Update for Community Board 8

E. 81st Street Pedestrian Bridge

HBPED100M

DESIGN CHANGES

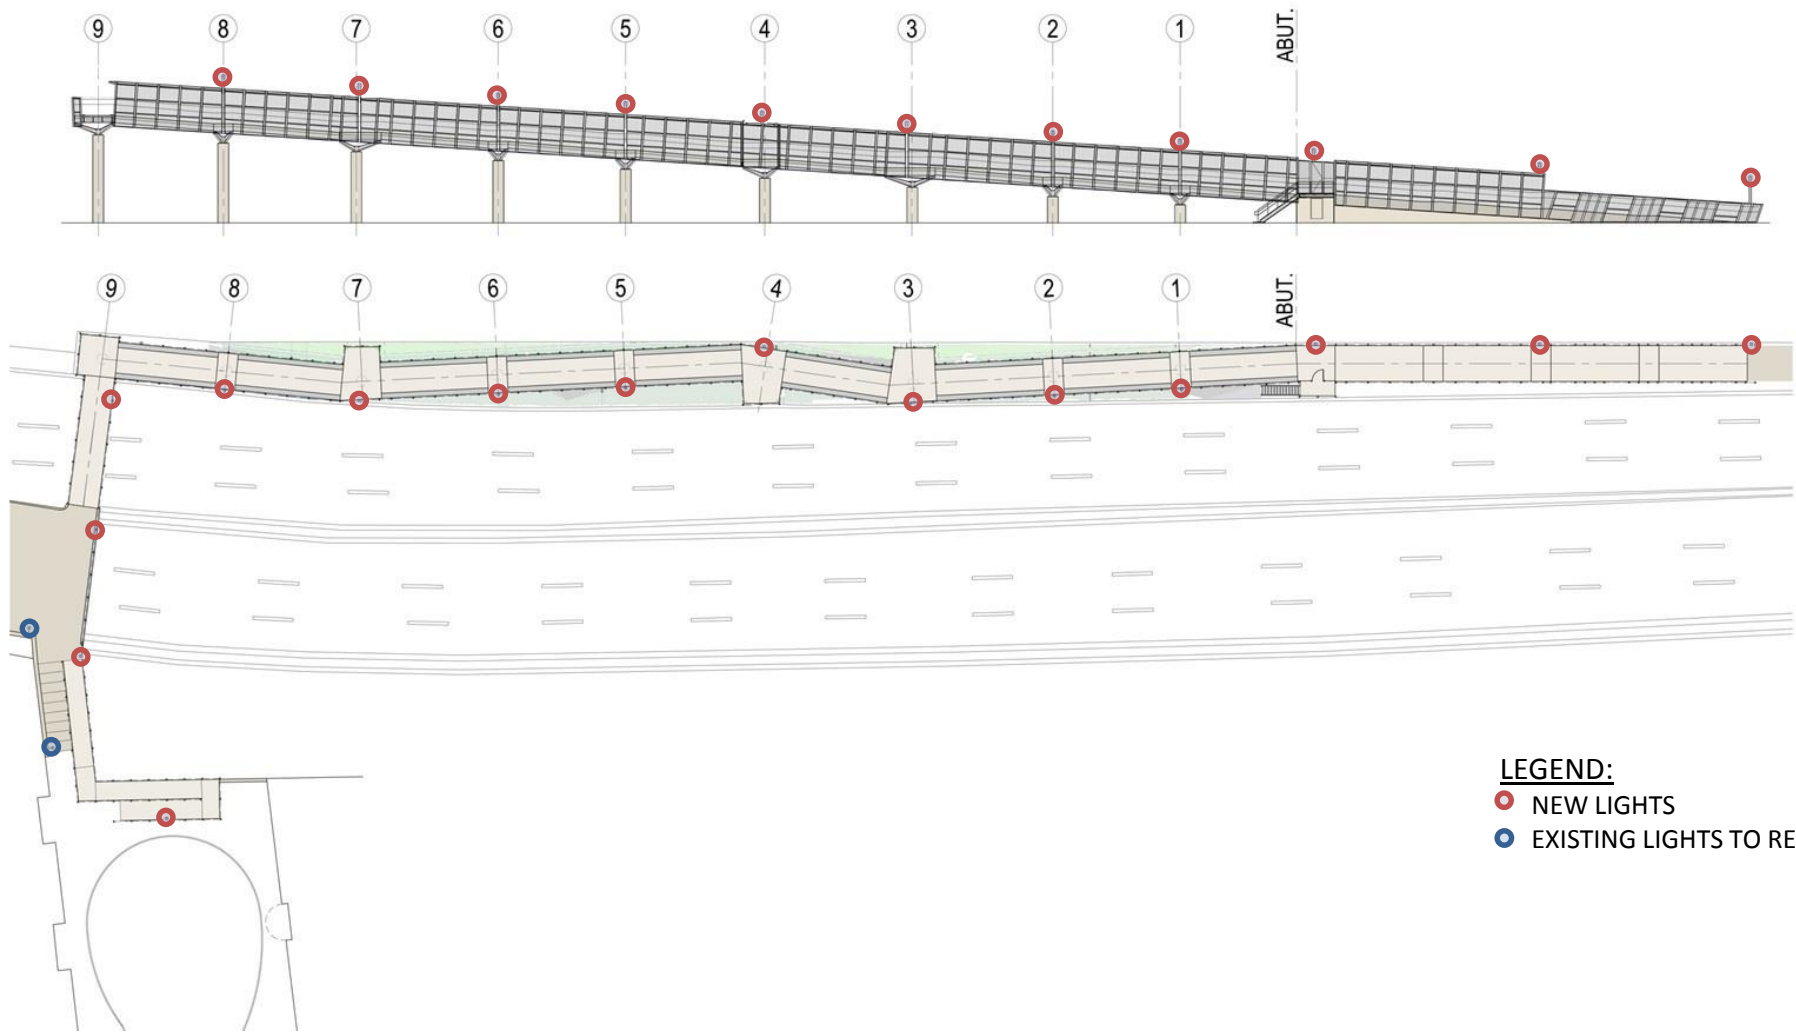
PDC Resolution requested the following changes:

1. Explore the Possibility of creating a viewing window at the southern terminus of John Finley Walk
2. Restudy the lighting fixtures to be more contextually appropriate and confirm the shielding is sufficient
3. Redesign the ADA ramp connecting East 81st Street to John Finley Walk to:
 - a) be more contextually appropriate, particularly with regard to the railing
 - b) eliminate or minimize new lighting
 - c) better resolve the pinch point at the adjacent residential building service entrance

Changes Made on the Lighting

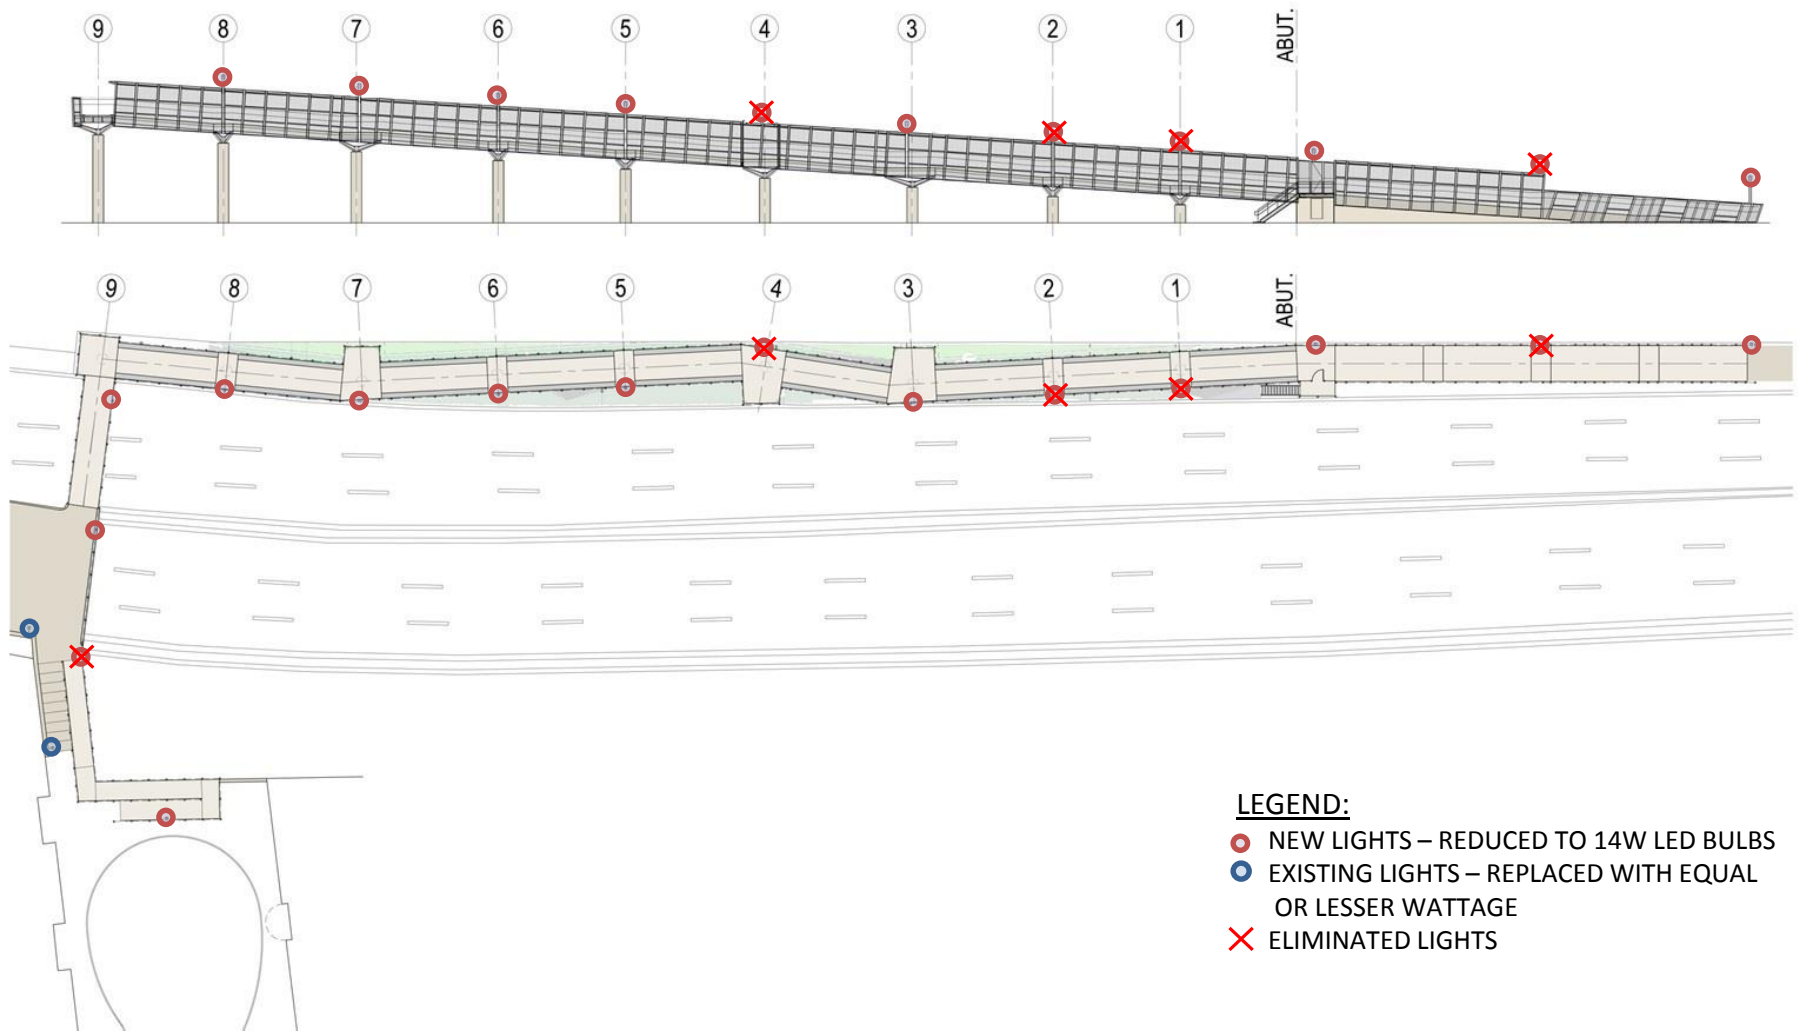
- Reduced new luminaires on pedestrian bridge to lowest possible wattage of 14W.
- Eliminated proposed light poles at the South Abutment, Pier 1, Pier 2, Pier 4, top of the E. 81st Street Stairs, and in the E. 81st Street cul-de-sac.
- Replaced existing Cobrahead luminaires at the 81st Street Stairs/Promenade with equal or lower wattage fixtures.
- Reduced luminance levels as shown in the following table:

Original Calculation	New Calculation
Max	75 Lux (6.97 Fc)	53.82 Lux (5 Fc)
Average	20 Lux (1.86 Fc)	19.27 Lux (1.79 Fc)

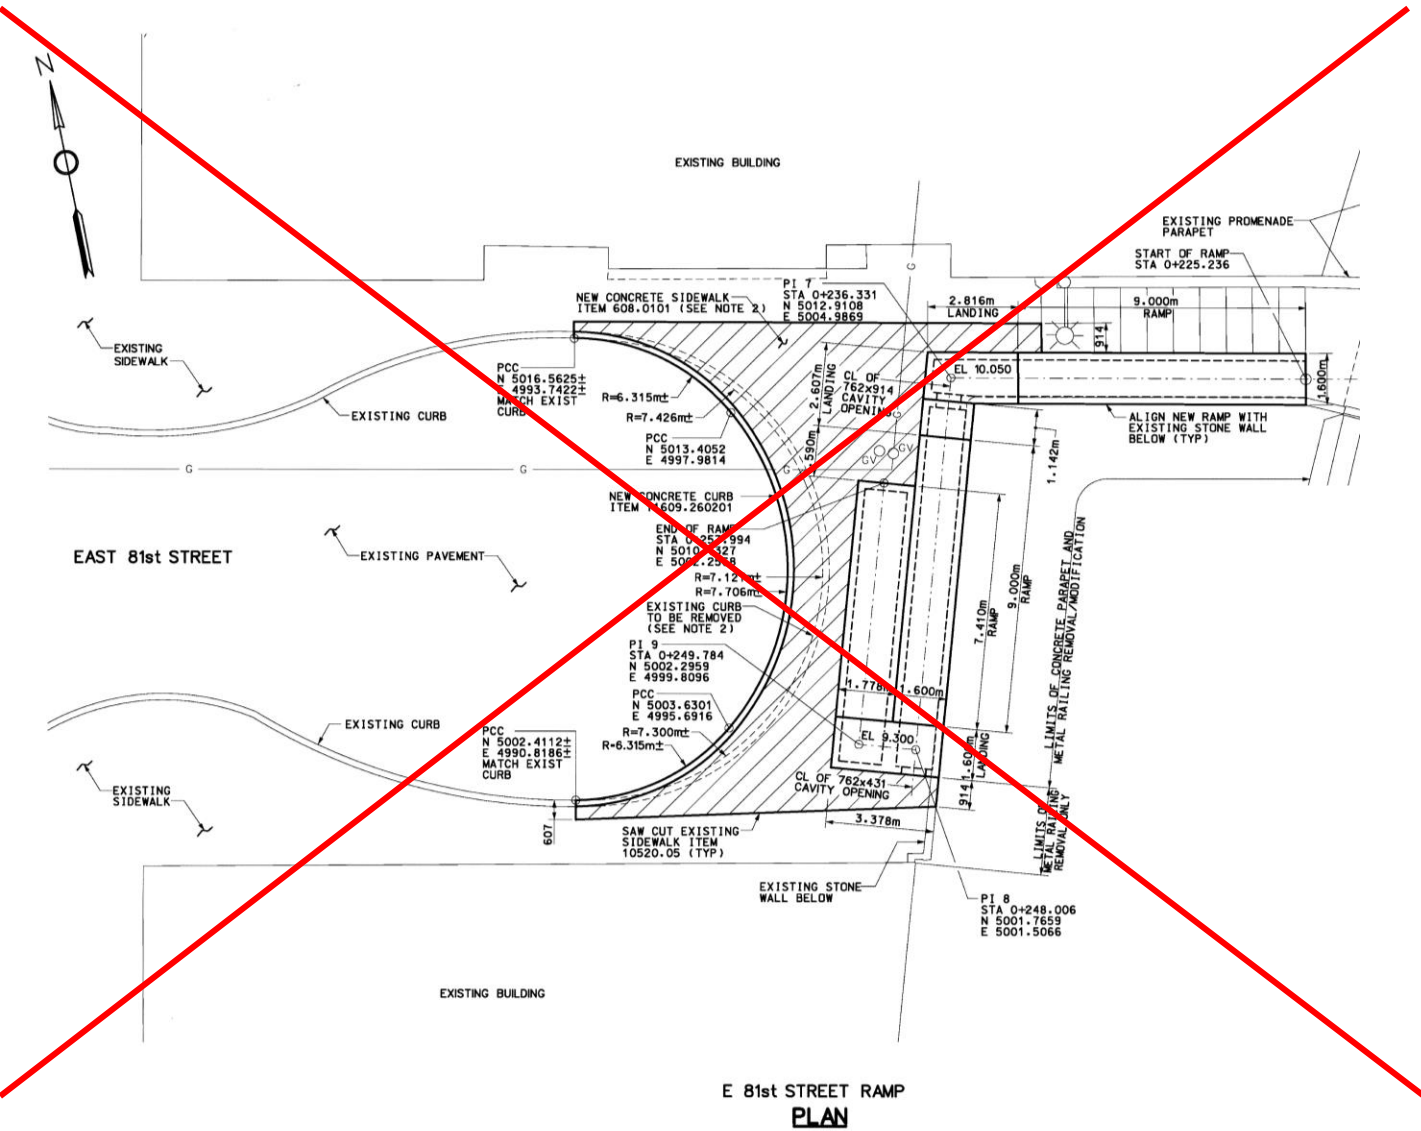
3. The Department of Parks and Recreation has decided to re-evaluate the question regarding access on the promenade holistically. During this evaluation process, DPR removed the cul-de-sac ramp from the scope of this contract.
